WORKSHOP #3—SEPTEMBER 17, 2009

QUESTIONNAIRE RESULTS/SUMMARY

PUBLIC SPACE (BOARDS 2A AND 2B)

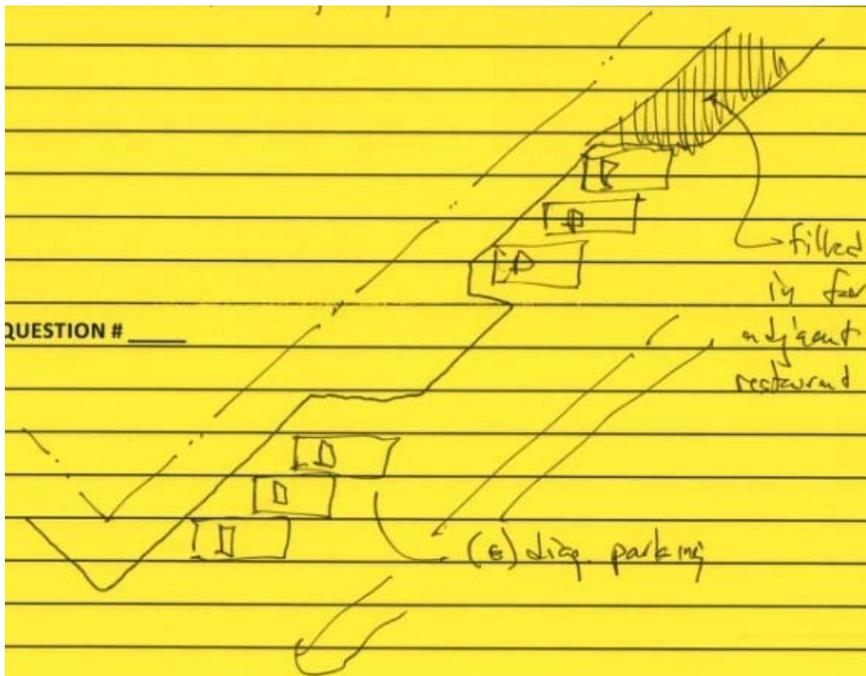
- Option 1—How about this instead of the 18' sidewalk [see photo]?

The Santa Cruz sidewalks benefit from localized widening. I propose the widened areas require a retail (restaurant) sponsor who will commit to using it, then we build it [see drawing below].
